MANDATORY SERVICE BULLETIN

Service Bulletin No. 579
Engineering Aspects are
FAA Approved

SUBJECT: Clearance Between Oil Sump Assembly and Oil Sump Baffle

MODELS AFFECTED: New, rebuilt, overhauled, or repaired Lycoming IO-540-L1C5; TIO-540-S1AD; IO-580-B1A series engines.

Figure 1. Sump Showing Acceptable Location of Wear Groove Clearance Cut

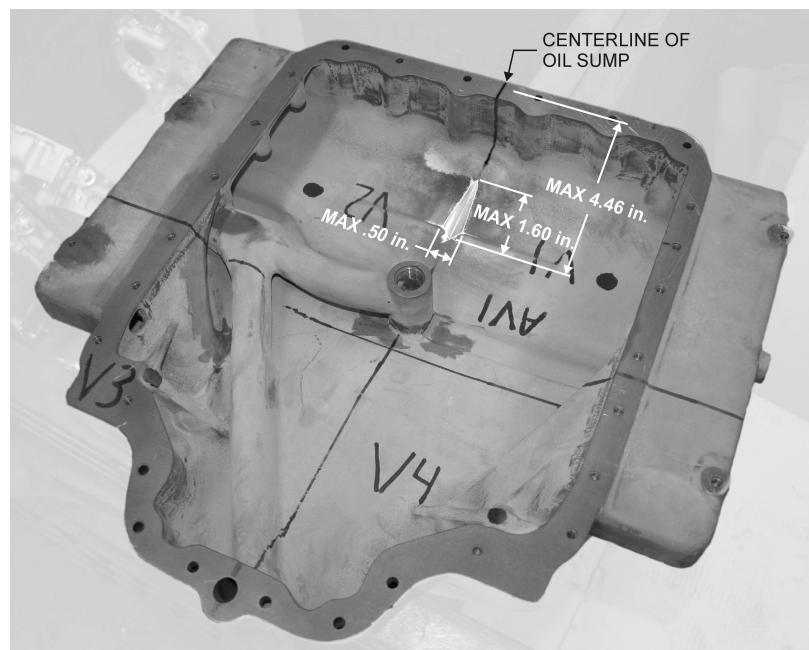
8. Thoroughly examine the inner surface of the oil sump for wear grooves.
9. If a wear groove exists on the bottom inner surface of the oil sump, towards the front of the crankcase, then an additional clearance cut must be made. If a wear groove does not exist, proceed with step 10. Affected sumps that already have been reworked at Lycoming will have the clearance cut at the centerline of the sump. If the clearance cut exists proceed to step 10.

- a. Using Figure 1 and 2 in conjunction with the outline of the existing wear groove, use a die grinder or other similar equipment to remove the material. Maintain existing surface finish. Deburr all edges.

Figure 3. Example of Oil Sump Baffle

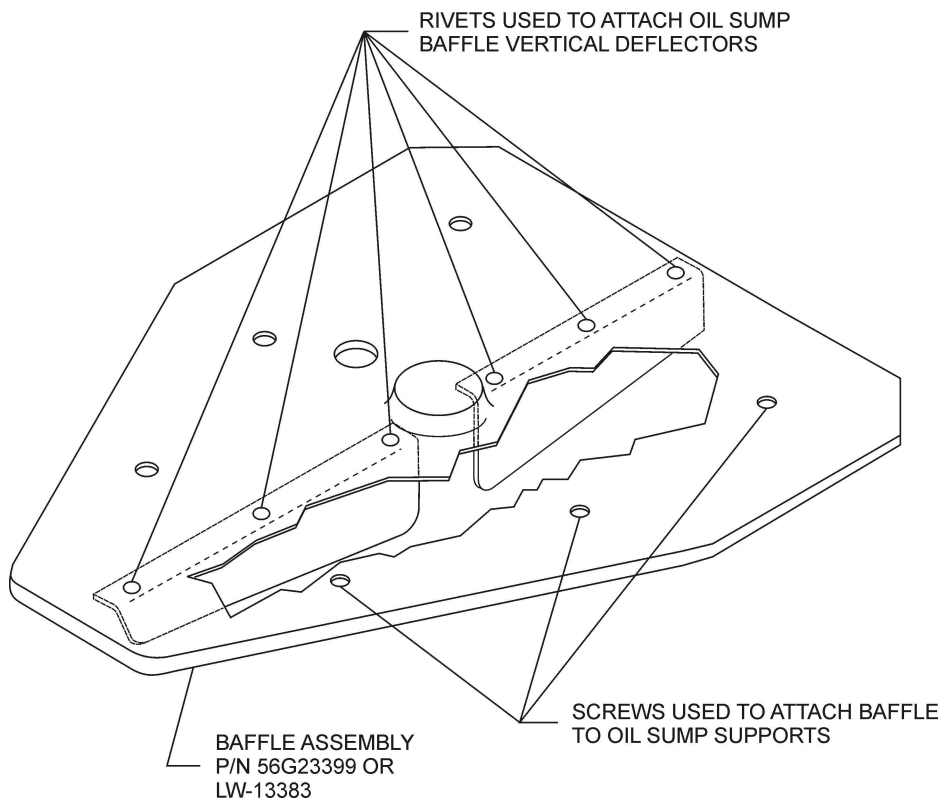
5. Examine the baffle. If the baffle is damaged, it must be replaced before reassembly. Examples of damage may include, but is not limited to, a deformed baffle plate, deformed fins, cracked attachment holes, or missing rivets. See Figure 3.
